**mcHF Hardware modifications as of April 29, 2015
as compiled by KA7OEI for
Version 0.3/4 UI and Version 0.4 RF boards**

Note: *Most, if not all, of these modifications may be applicable to board versions other than the Version 0.3 UI board or Version 0.4 RF board, provided that care be taken to accommodate board/circuitry differences. Note that most of the modifications to the Version 0.3 UI boards (and earlier) have been incorporated in some way into the 0.4 UI board and need not be done!*

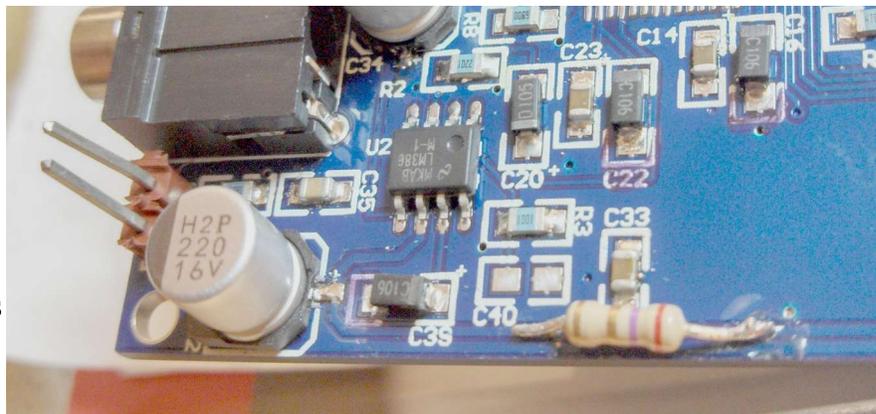
It was also observed that the voltage at C96/RFC7 was not properly following the setting of the **PA Bias** adjustment. This turned out to be due to the fact that U18, an LM2931, like many regulators, has a **minimum** load current requirement for regulation.

If you look at the diagram you will note that there is **NO** DC loading on the DC output from this regulator as the gates of the PA transistors are purely capacitive. If leakage currents from U18 exceed those of C96, C101, Q5 and/or Q6, the voltage on this line can exceed the regulated output. Similarly, if there **are** leakage currents through C99 and/or C100 due to the components, board contaminants, moisture or other sources, this can also cause the voltage to rise.

What this means is that the bias voltage can not only exceed the setting for **PA Bias**, but it may not turn off when in receive mode which could mean that the PA transistors may conduct current and generate heat **EVEN IN RECEIVE MODE!**

Install a resistor in parallel with C96. The value of this resistor may be anything from 470 ohms to 10k: I used 2.2k since I had plenty of them left over from construction, but I'd recommend 470 ohms or 1k to more-quickly discharge the 100uF capacitor installed above.

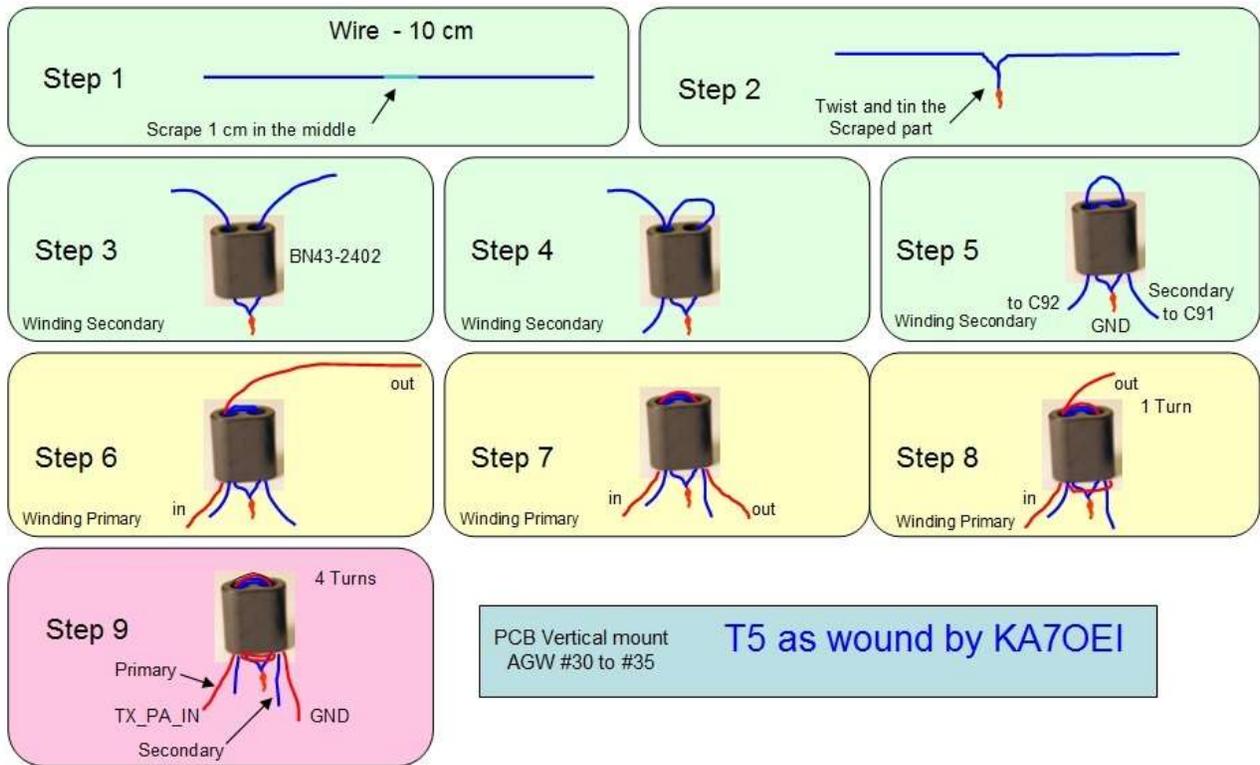
It has been observed that with the original component values of R59/R60 and R58/R62 in the power detector, a static voltage of approximately 200 millivolts was present on the “PWR_FWD” and “PWR_RET” lines. Inspection with an oscilloscope revealed the presence of a very narrow pulse emanating from the MCU's A/D input lines of significant voltage, charging the capacitors (C82/C83) and this “bias” voltage was the result. Because the full-scale A/D voltage is just 3.3 volts, this 210 millivolt “bias” (approximately) represented a significant portion of the A/D range (approx. 6-7%).

Another potential problem that was observed was that the voltage being output by the power sensor exceeded 3.3 volts, a voltage above the A/D input range, at power levels below 10 watts – a power level attained on some bands by some users.

- Remove R59 and R60 and replace with zero-ohm resistors or jumpers.
- Change R58 and R62 to 2.2k resistors.
- Change C82 and C83 to 2.2uF capacitors.
- Replace R55 and R56 with 47uH inductors. If you do not have these, 4.7 uH inductors will work adequately.
- Additionally, it is recommended that one capacitor each of 1nF to 100nF be connected between pins 9 and 10 of the 30 pin edge connector on the RF board and ground (pin 6).

Step-by-step winding guide for constructing "T5"

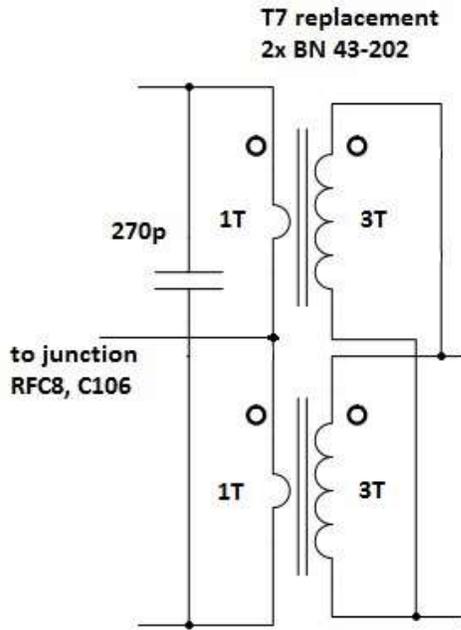
The original part number for transformer T5 on the RF board called for a 1:4(CT) transformer, but a circuit analysis will indicate that this is inappropriate for the impedance of Q4/Q5, the RF Driver transistors. The current BOM calls for a 1:1(CT) transformer – a “less bad” match, but still not ideal in that there is a mismatch causing ripple/loss in the bandpass filters but it is less severe than with the original 1:4 impedance.

A better transformer would be a 4:1(CT) transformer. Unfortunately, one cannot simply turn the original transformer “backwards” since it lacks a centertap on the necessary side in order to properly drive Q4/Q5. Fortunately, it is easy to wind a custom transformer using a BN43-2402 core – the very same core used for RFC8 – and some small-diameter wire.

This reworked transformer is small enough to be soldered to the original pads occupied by T5: Just make the leads as short as practical.

Photographs of the completed T7. On the left can be seen the 270 pF capacitor across the primary of the transformer while on the right can be seen the connection to the output of the secondary winding.

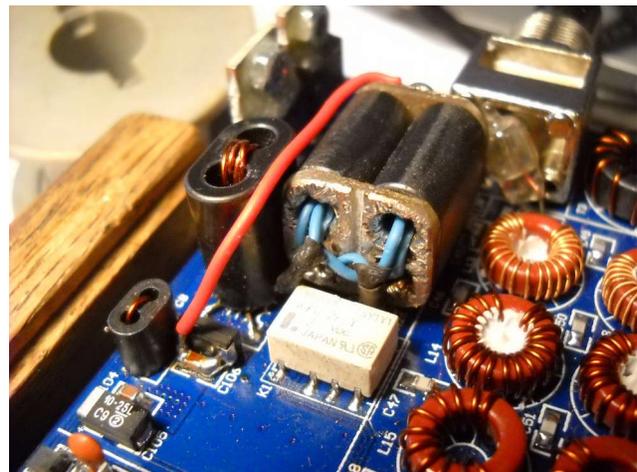
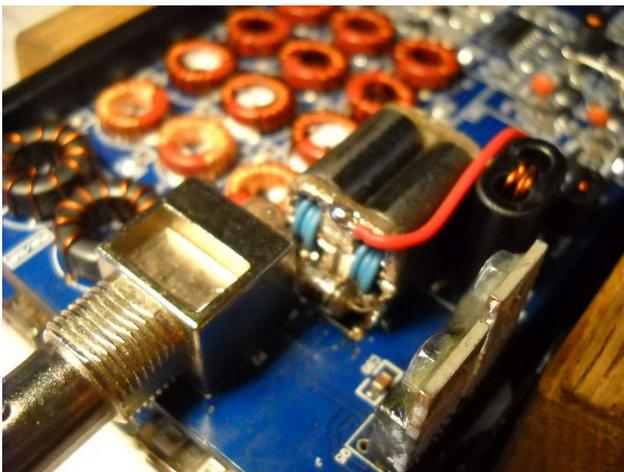
As it turns out there has been quite a bit of discussion related to the ability (or inability) experienced by some users of the mcHF to output a “solid” 5 watts on higher bands. Careful analysis by some of the folks on the Yahoo group has shown that the original transformer design suffers from a few design deficits, namely:

- Primary/Secondary coupling not as tight as it should be
- Excessive leakage inductance
- Transformation ratio not optimal for maximum power output at good efficiency
- Reactance of transformer not compensated

The drawing depicts two identical transformers sharing a “primary”, center-tapped winding and paralleled secondary with a 270 pF capacitor (*rated for 200 volts or more*) connected across the primary to compensate for the reactance and improve performance.

If one looks closely at the above pictures it can also be seen that on the “center-tapped” side of the primary (the left-hand photograph) a piece of copper-clad printed circuit board is used to connect the primary windings (the coax braid) inside each core together. While this makes for a very neat construction, it is not absolutely necessary, but if flat, copper material – such as PCB material or copper sheeting/flushing – is not used it is recommended that multiple strands of bare, copper wire be used to bond them together.

Finally, although not shown on the schematic or visible in the left-hand photograph, it is recommended that a 0.1uF capacitor be connected between ground and where the V+ (red wire in the photograph) is connected on the two cores for optimal RF bypassing.

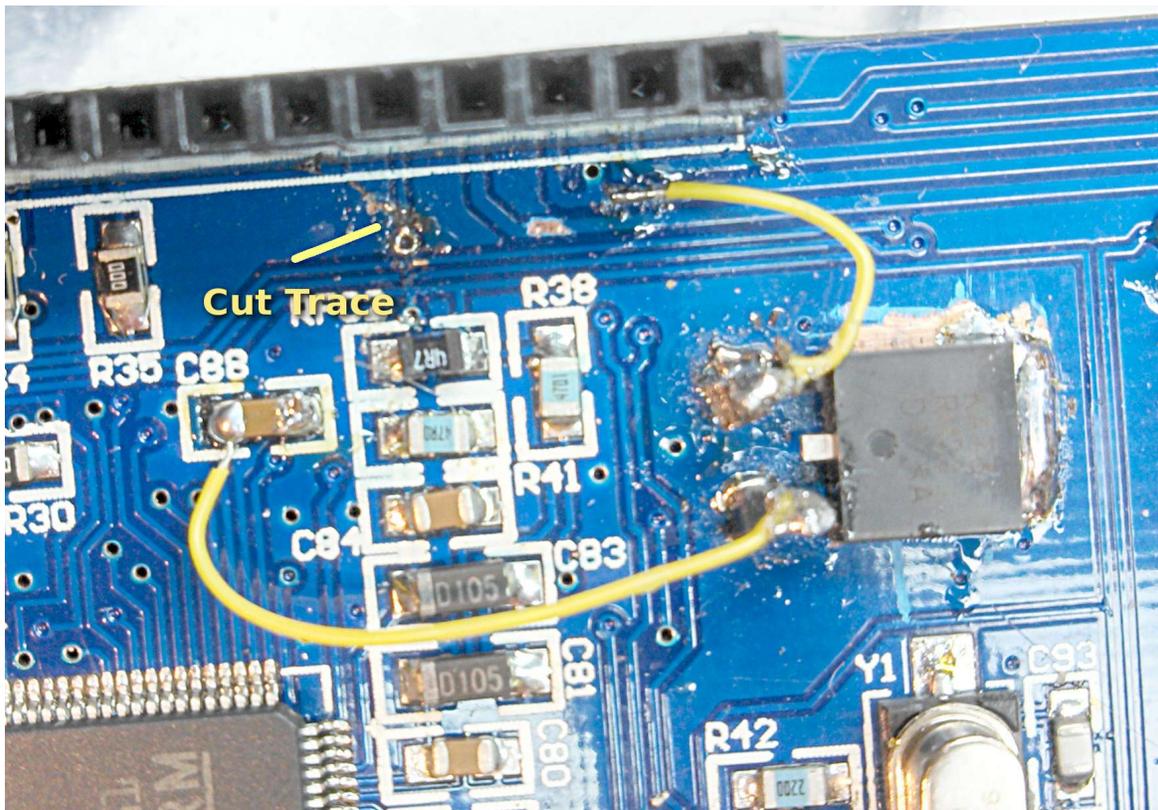
It may be noticed by those studying the diagram – or having happened to make current measurements of the transceiver – that PA driver transistors Q3 and Q4 are *always* biased on. Because of this, an extra 30-60 mA is consumed at *all* times when the power is applied to the transceiver: During receive and even when it is turned off!

to the VCC_12 volt supply – which is always on. R73/R75 also provide a degree of RF degenerative feedback from the collector to the base of the transistors and reduce their impedance as well, possibly causing an increased mismatch to the output of T5, further reducing RF output, particularly at higher frequencies.

- Change R74, R76 to 2.2k
- Remove R73, R75
- Where R73, R75 would be, stand on end, in each location, a 2.2k resistor, the bottom end connecting to the base of transistors Q3, Q4.
- Solder, standing on end, 100nF capacitor(s) to the ground end of R74 and/or R76.
- Connect the "top" of these components (the two resistors and the capacitor(s)) together.
- Connect the tops of these components to the junction of R15 and Q1a (at R15) using a piece of very thin, insulated wire: I used #30 AWG wire-wrap wire, tacked down in several places with small dots of thermoset ("hot-melt") glue.

Unfortunately, reports indicate that this can cause instability to some users so this recommendation is withdrawn: Continue using 47nF capacitors at these locations!

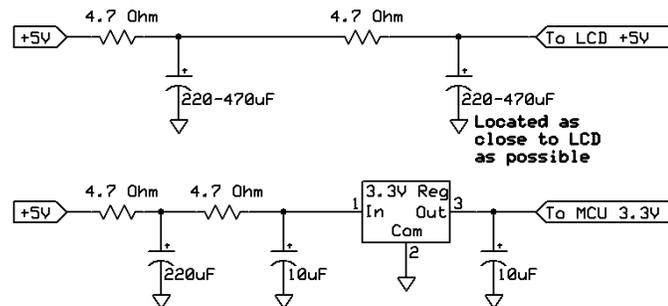
It was noted that when the above modification was completed that there was residual noise on the 5 volt line so further investigation was carried out. It turned out that the remainder of the noise was from two sources:

- The +5 volt supply for the LCD
- The transmission of noise **through** the 3.3 volt regulator.

When the “LCD Backlight Brightness” control function was added, the need for even better filtering of the LCD's power supply was made apparent as the modulation of the LCD's power supply current rippled (literally!) throughout the rest of the receiver!

The diagram shows the filtering in schematic form. There is a voltage drop associated with each resistor, but each is well within the range of the associated device.

- The LCD has an internal 3.3 volt regulator that has a (worst-case) dropout voltage of 600mV – and less than 1 volt is dropped across the two 4.7 ohm resistors.
- The MCU regulator drops less than 250 mV per 4.7 ohm resistor, leaving well over a volt of headroom for the low-dropout regulator.

Diagram depicting the MCU's own, isolated 3.3 volt power supply. This also shows additional isolation of the LCD power supply as well as the suggested, separate 5 volt power supply for the UI board - see text.

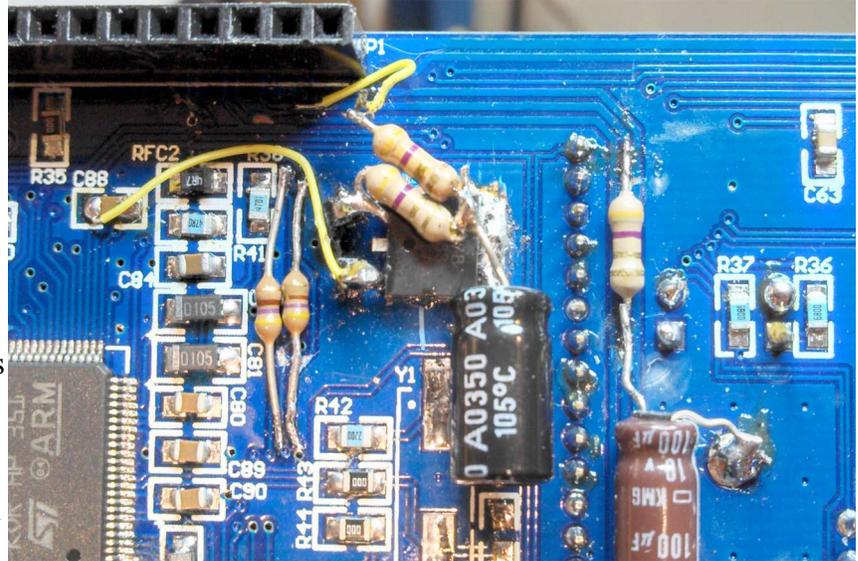
Note: Additional isolation will be obtained if the LCD, MCU and USB +5 volt supplies were derived from a separate 5 volt regulator on the UI board, powered from the +8 volt rail as depicted below.

For LCD filtering, place the noted capacitor as close to the LCD's pins as possible – preferably **at** the LCD itself! The 4.7 ohm resistors and the other capacitor may be placed farther away, but the second capacitor should be placed as close to the LCD's ground as well.

On the 3.3 volt MCU regulator, the 220uF capacitor on the input side of the 3.3 volt regulator, along with the 4.7 ohm resistors, form a low-pass filter that provides an impedance path between the noise source at the input of the regulator and the capacitor, greatly improving its ability to filter. The other 4.7 ohm resistor provides isolation between the noise that remains at the 220 uF capacitor and the rest of the 5 volt bus in the transceiver.

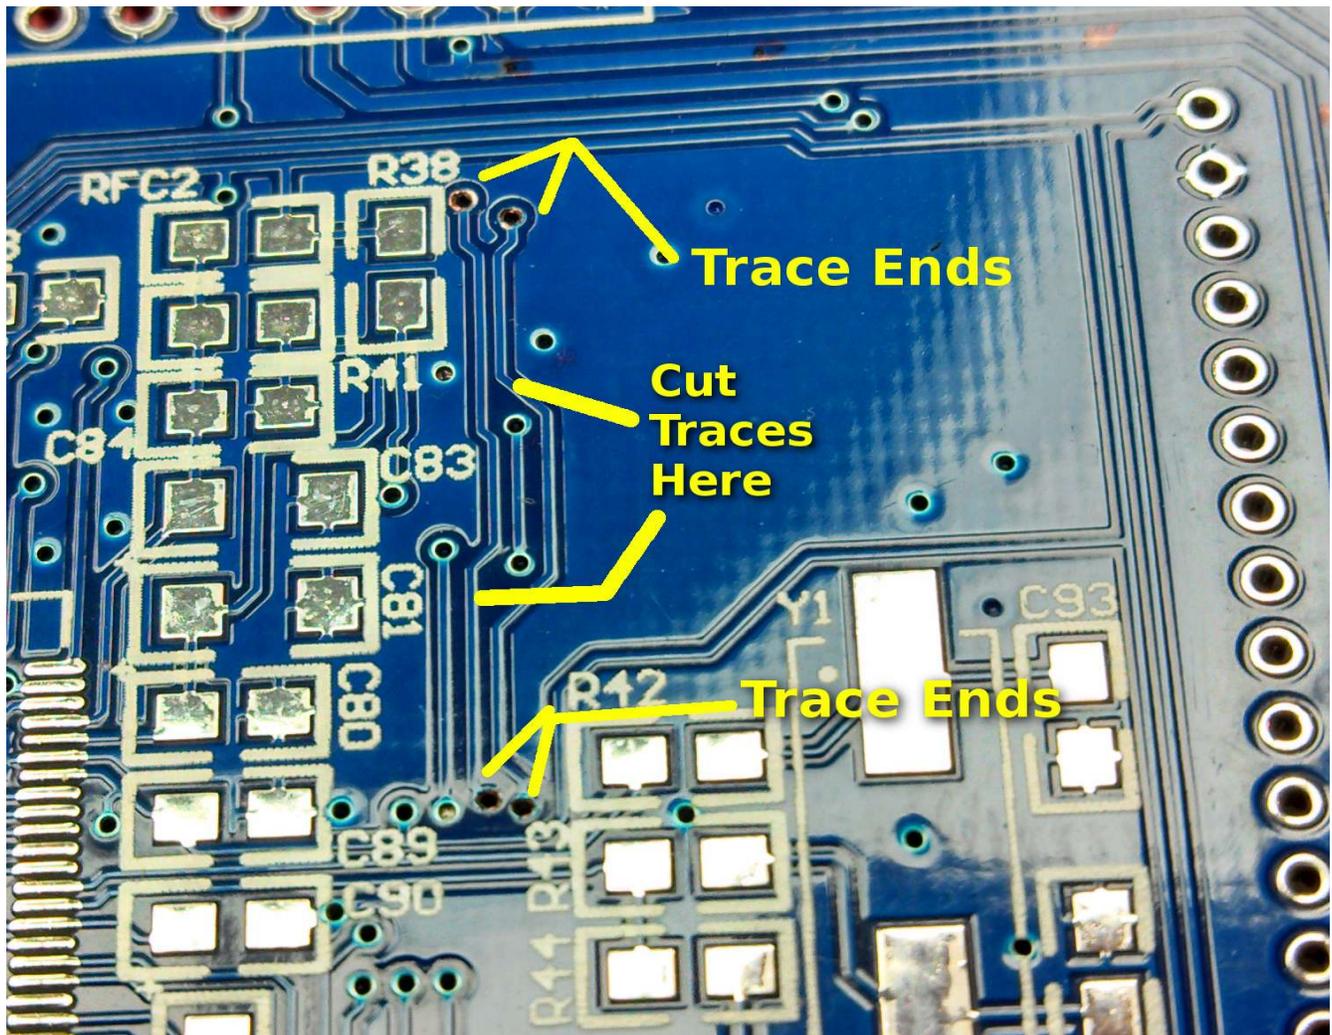
If the above modifications are made, with no antenna connected – or even with an antenna connected when listening on higher bands (especially 20 meters and above) a fairly strong “tick” may be heard every second. This is due to the polling of the onboard temperature sensor and the fact that the “fall” time of the on the I2C line from the MCU is extremely fast and rich with harmonic energy. This problem can be easily “fixed” with the addition of resistors on the UI board in series with the SCL and SDA lines which effectively reduce the slew rate of these lines, quashing the RF energy.

A reasonable value of resistor to install is 470 ohms and the installed components may be seen in the picture.
